## **ATTACHMENT B – TECHNICAL ASSESSMENT**

This document 'Attachment B' contains the Technical Assessment of the State Significant Development Application (SSD) for the Telopea Stage 1A and Concept Plan Application. It provides a further detailed assessment in addition to the formal submission, as well as assessment of matters relating to Biodiversity, Waste Management, Catchment Management and Drainage and Contamination. It should be read in conjunction with Council's submission which was endorsed by Council at its meeting on 22 November 2021 and Attachment A summary of Council's recommendations.

**Table 2:** Council's calculated maximum allowable FSR under PLEP 2011 and State Policies

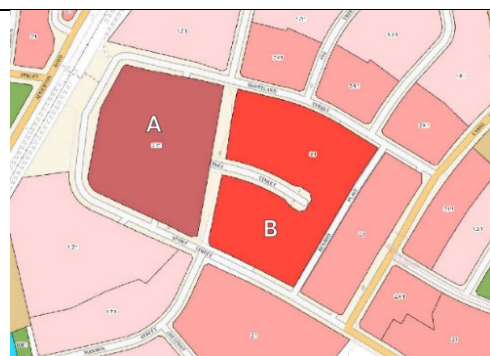
Council has calculated the maximum permissible FSR for the Core (C1 – C8) in **Table 2** below, including available FSR bonuses as 168,409sqm. Therefore, Council concludes the proposal exceeds the maximum allowable FSR by over 18,000sqm (or approx.10.7%).

**Figure 4:** Plan indicating extent of public open space and encroachment of basement.

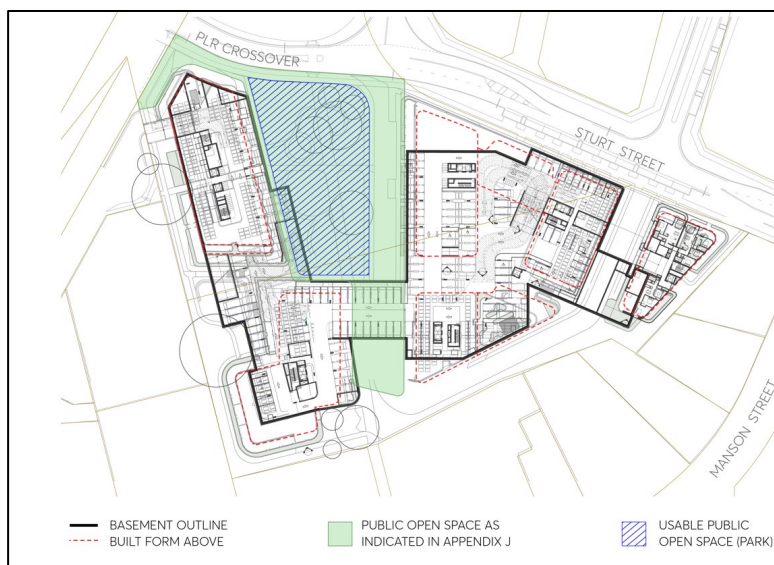
- b) Removal of the underground carparking that encroaches along the south-western interface (refer **Figure 4** below) and is to be removed to ensure deep soil throughout.

Figure 05 - Telopea Precinct Street Setction

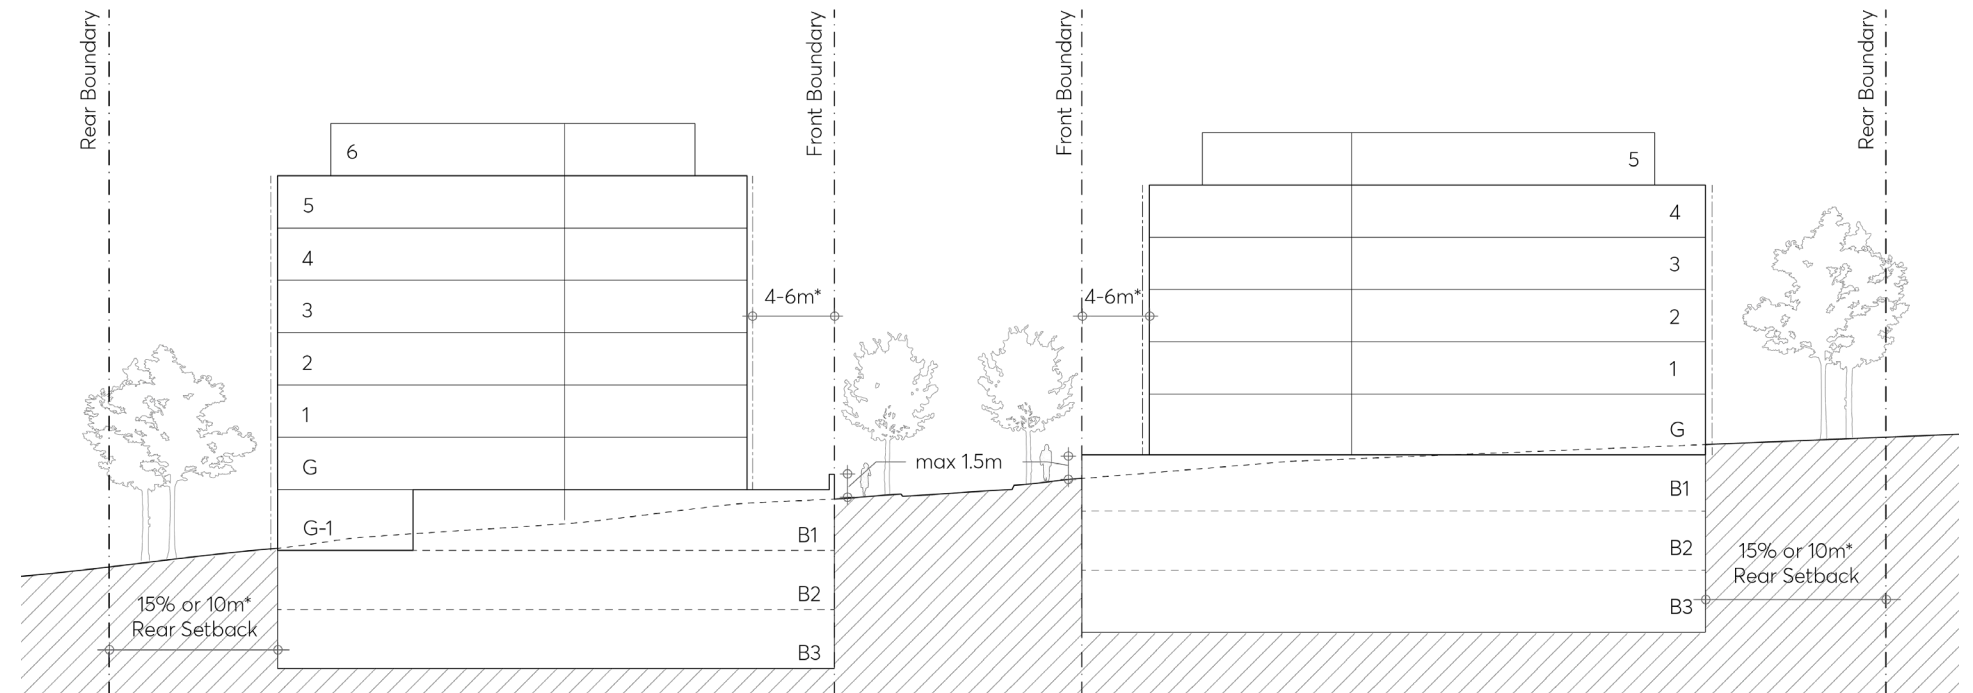
Development on all sites must comply with the 4m to 6m front setback to create a continuity of the streetscape. The proposed 3m setback will not deliver on objectives for the front setback to contribute to tree planting and will greatly diminish the perceived proportion of the street width to building height ratio.
